**RESPONSE TO ENVIRONMENTAL PROTECTION
AGENCY'S DRAFT NPDES PERMIT**

**PSNH MERRIMACK STATION
UNITS 1 & 2
BOW, NEW HAMPSHIRE**

**Prepared for
Public Service Company of New Hampshire**

February 2012

Figure 1: Spacing Criteria for Johnson CWW Screens [Ref. 6.19]

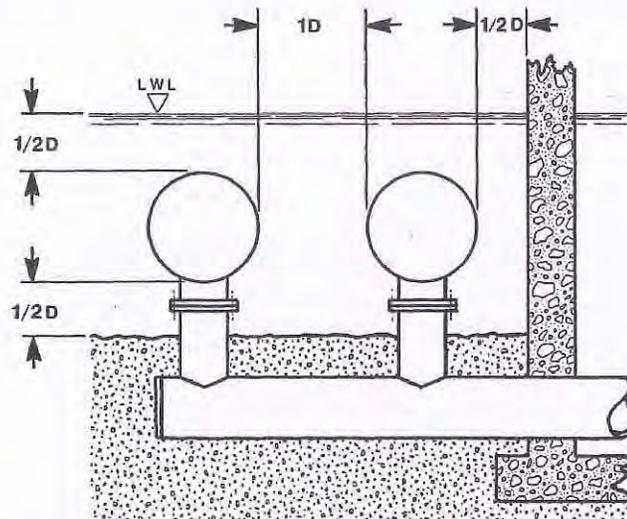
In the draft permit, EPA also concludes that the Merrimack River is too shallow for CWW screens. The 2009 Report [Ref. 6.2] indicated that a CWW screen diameter of 24 inches was chosen for the design of Merrimack Station to take into account the mean low water level of 4 ft. Correspondence with Johnson Screens, the leading CWW screen manufacturer, indicates that one half diameter of clearance must be provided above and below the outer edge of the screen [Ref. 6.2]. The Product Application Guide from Johnson Screens [Ref. 6.19] also gives this spacing requirement, shown in Figure 1. For a 24-inch diameter screen, this signifies a requirement of one foot of water above the top of the screen, and one foot of water between the bottom of the screen and the bottom of the river. Therefore, 24-inch diameter CWW screens can be designed to operate in as little as 4 ft of water.

The 2009 Report presented a preliminary layout of CWW screens. This preliminary layout showed CWW screens being installed from approximately 60 ft to approximately 95 ft offshore in front of the existing Unit 1 and 2 screen houses [Ref. 6.2]. As discussed in the 2009 Report, the mean low water level in the vicinity of the CWW screens is 4 to 6 ft, with an average depth of 6 to 10 ft. Crude bathymetry data provided by Normandeau for the lower Hooksett Pool demonstrated water depths of approximately 7-15 ft along this transect in the region closest to where the CWW screens would be installed (Attachment 1, Section 2). This data is obtained from the N-5 transect, located just south of the intake structure [Ref. 6.11]. More detailed bathymetry data would be necessary to confirm the depths of the river in this area, but currently available data suggests that water depth would not be an issue for a 24-inch diameter CWW screen installation.

Figure 3: Existing Open-Cycle Cooling Flows at Merrimack Station

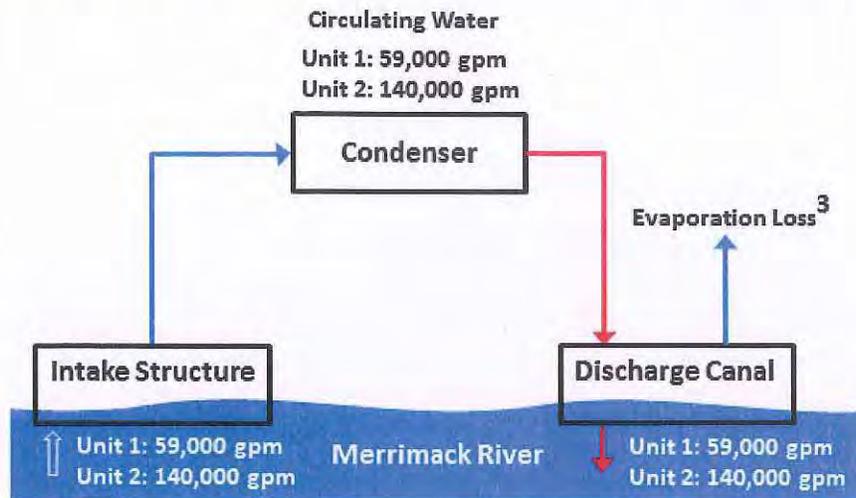
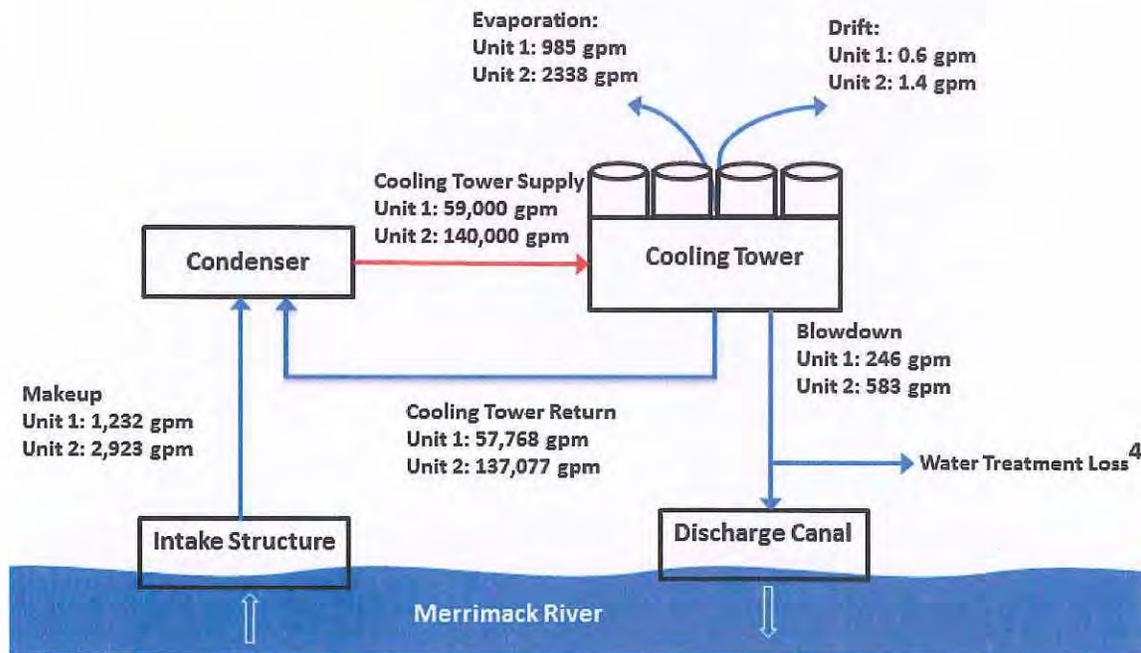
In the draft permit, EPA states that the PSNH estimation of the impact of additional evaporation upon the Merrimack River errs on the high side because it does not take into account evaporation already occurring in the existing cooling system. Although this statement is technically correct (the evaporation resulting from operation of the current system was not included in the estimation), the current cooling system evaporates only a very small amount of water, especially when compared to the evaporation that would occur using a wet or hybrid cooling tower. Unlike cooling towers, the primary mechanism by which the PSMs cool water is convection, and not evaporation. Additionally, the existing

Simplified schematics of the closed-loop and open-loop cooling water system configurations are shown in the Figures below; Figure 3 depicts the existing open-cycle configuration, while Figure 4 shows a potential closed-cycle configuration. It is estimated that the closed-cycle cooling system would consume approximately 3,325 gpm of water. This amount of water loss is equivalent to approximately 2,640 Olympic-sized swimming pools per year [Ref. 6.21]. Note that several smaller miscellaneous loads (e.g., slag sluice, de-icing recirculation, travelling screen wash, equipment cooling, fire water, etc.) are not included in the schematic diagrams below for simplicity.

It is important to note that while a closed-cycle cooling system draws significantly less water from the river than an open-cycle cooling system, it consumes significantly more
